August 9, 2024

RE: JBRA CPD (Planned Development Rezoning Application) DCI2024-00023

The Zoning Section has reviewed the information provided for the above-referenced application. The Lee County Land Development Code (LDC) requires additional information for the application to be sufficient. Please respond to each requirement not satisfied on the attached checklist. For your assistance, we have enclosed any additional memoranda from the various Lee County reviewing agencies.

PROPOSED FLOOR PLAN

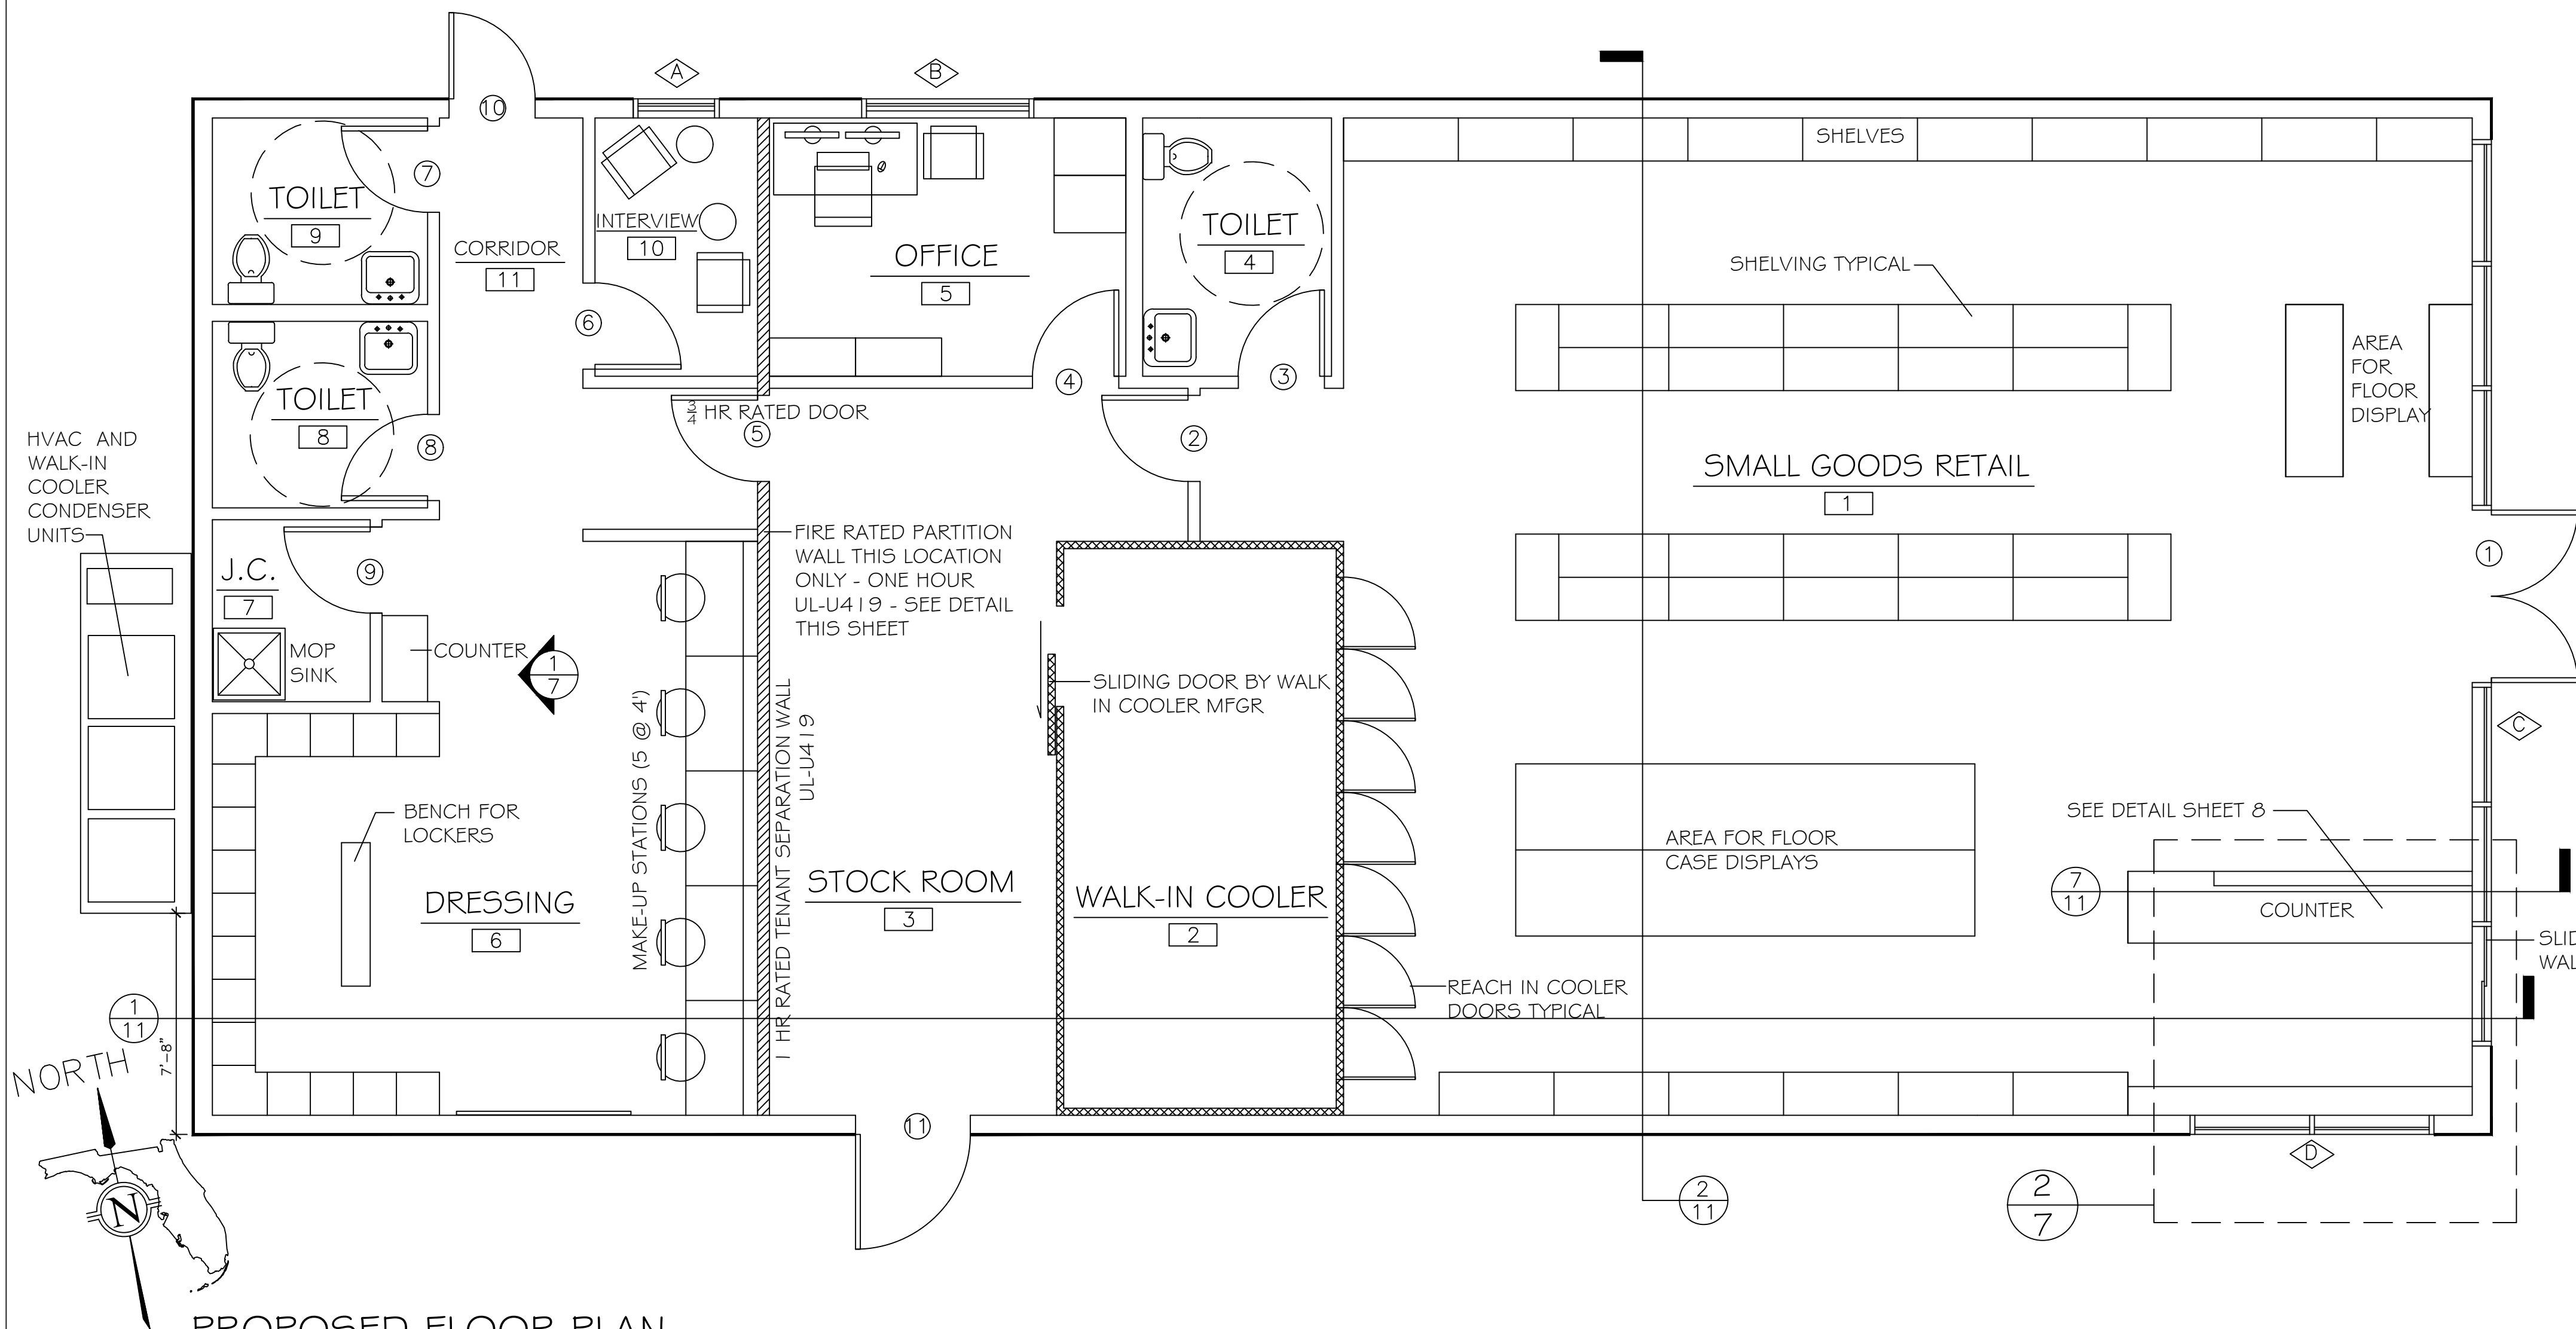
3. COM2024-00820 (Project Name: Vixen's Small Goods Retail Store). Staff is in receipt of the above-referenced companion interior remodel permit request at 19260 San Carlos Boulevard. The Proposed Floor Plan (see *Attachment*) depicts a portion of the proposed floor area for package sales, including backstock and administrative office area, and a separate floor area allocation for use incidental to adjacent adult entertainment business under common ownership. Please clarify/classify the intended use and assess parking calculations accordingly, and if applicable, provide analysis of LDC Sections 34-1201 through 34-1204.
